# **METRO PLANNING COMMITTEE OF THE TOWN PLANNING BOARD**

**MPC Paper No. 10/15  
For Consideration by  
the Metro Planning Committee on 17.7.2015**

**Further Consideration of the Draft Planning Brief  
for the “Comprehensive Development Area” Site in Diamond Hill**

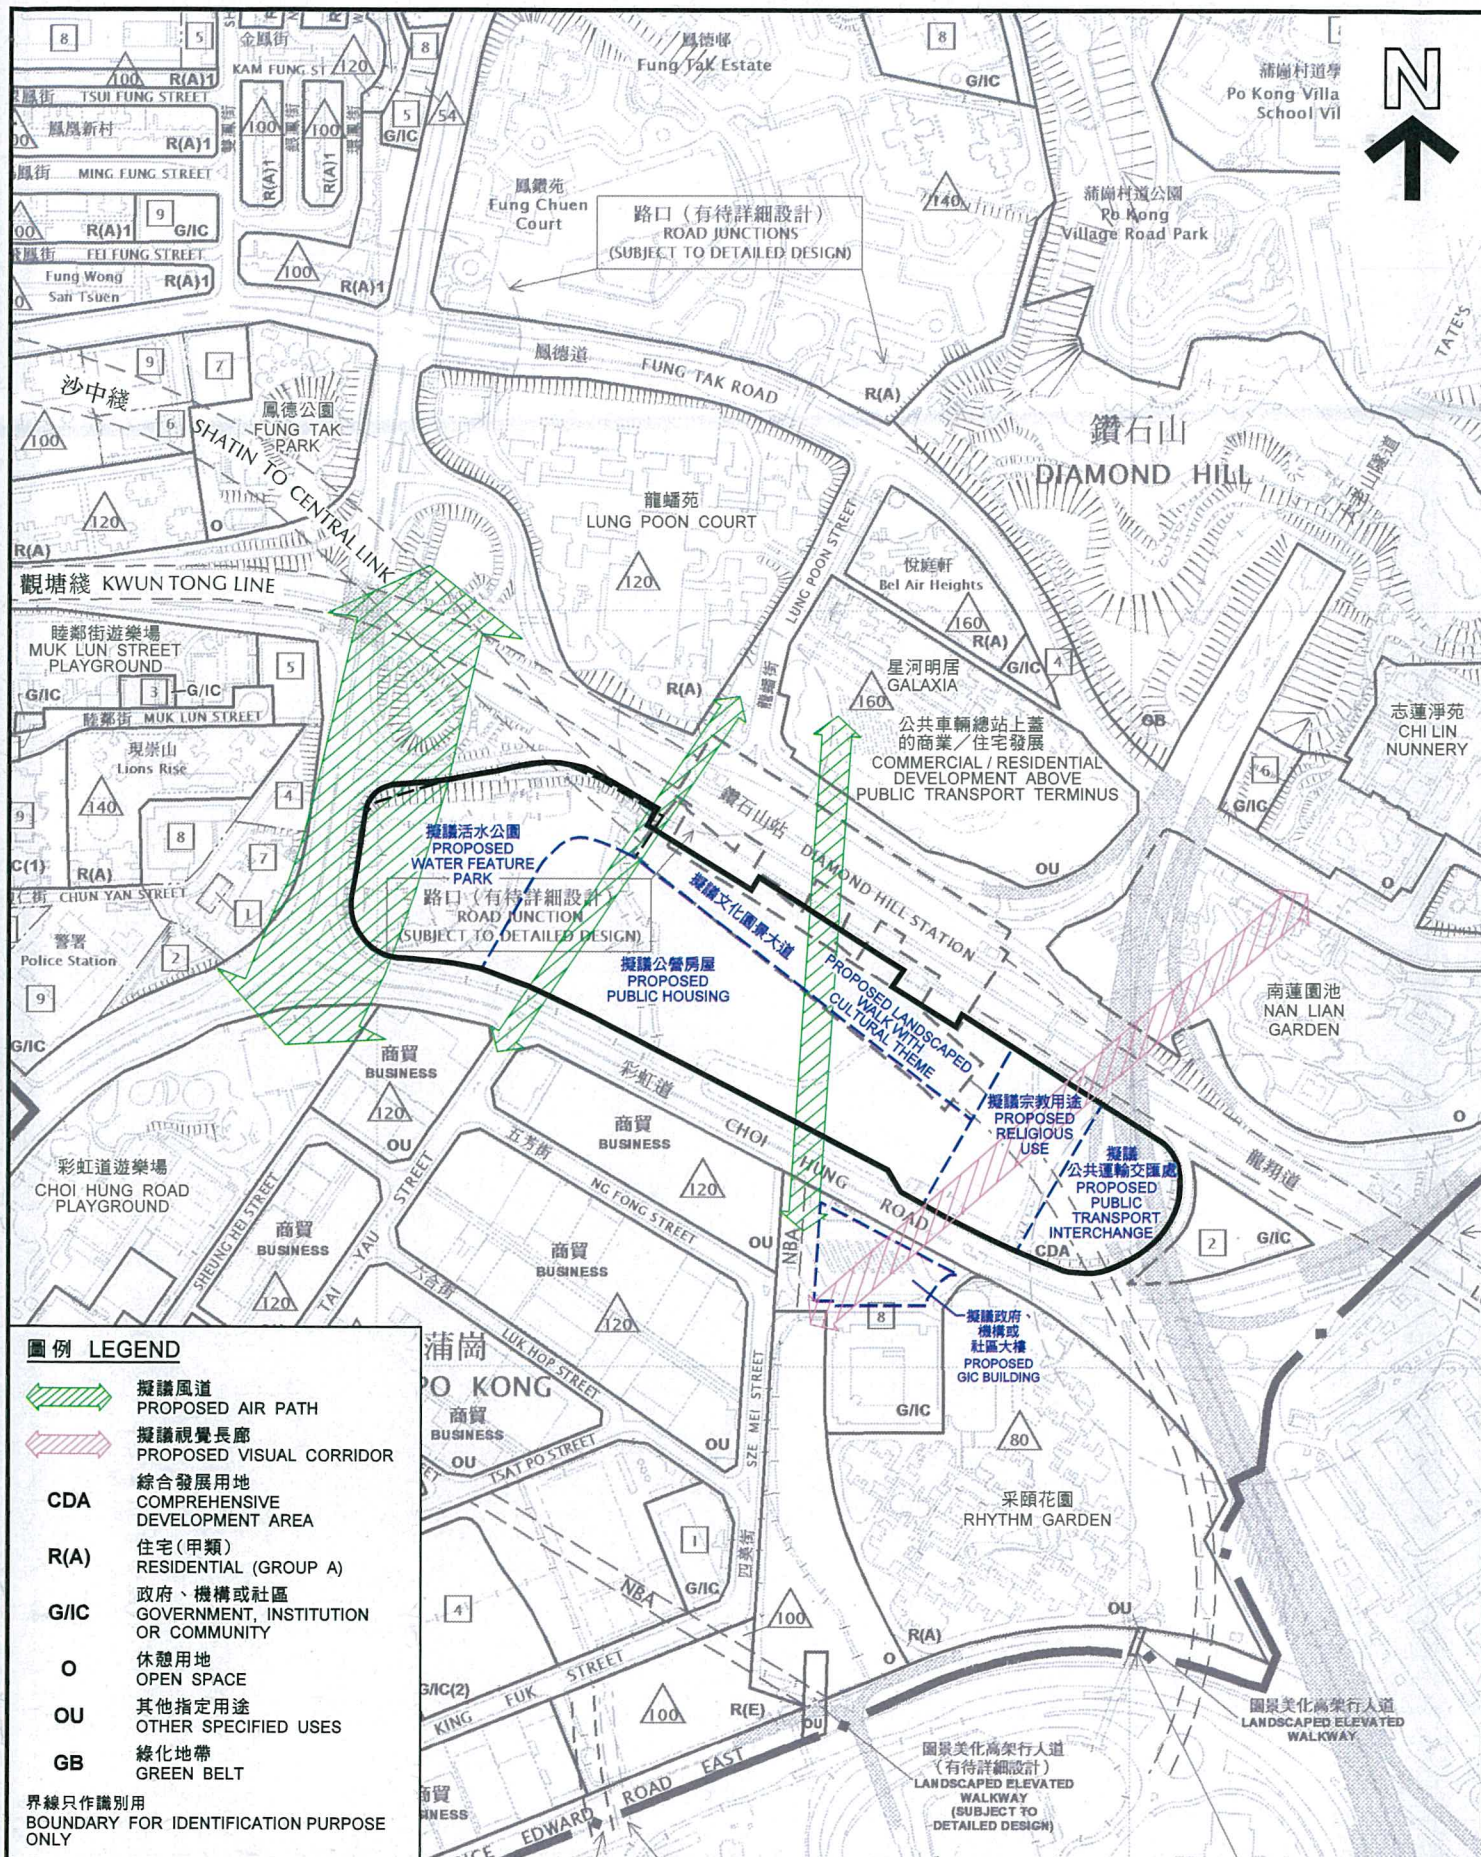
- (b) in order to promote better air ventilation in the surrounding areas, the number of main air paths within the Site should be increased from 3 to 5 as indicated in the previous conceptual proposal;

- (b) in accordance with the recommendations of the air ventilation assessment (AVA) for the OZP area carried out by PlanD in 2008, the draft PB has stipulated the preservation of 3 air paths within the Site to facilitate air ventilation with the adjoining areas. Being connected with major streets and open space, they are more effective in air ventilation terms. While HD's previous conceptual proposal has indicated 2 more air paths between the building blocks, they will be subject to the actual design of HD. To provide flexibility, the location of these further air paths between buildings is not specified in the draft PB. However, the draft PB has specified the requirement to provide additional air paths upon more detailed design at the MLP submission stage;
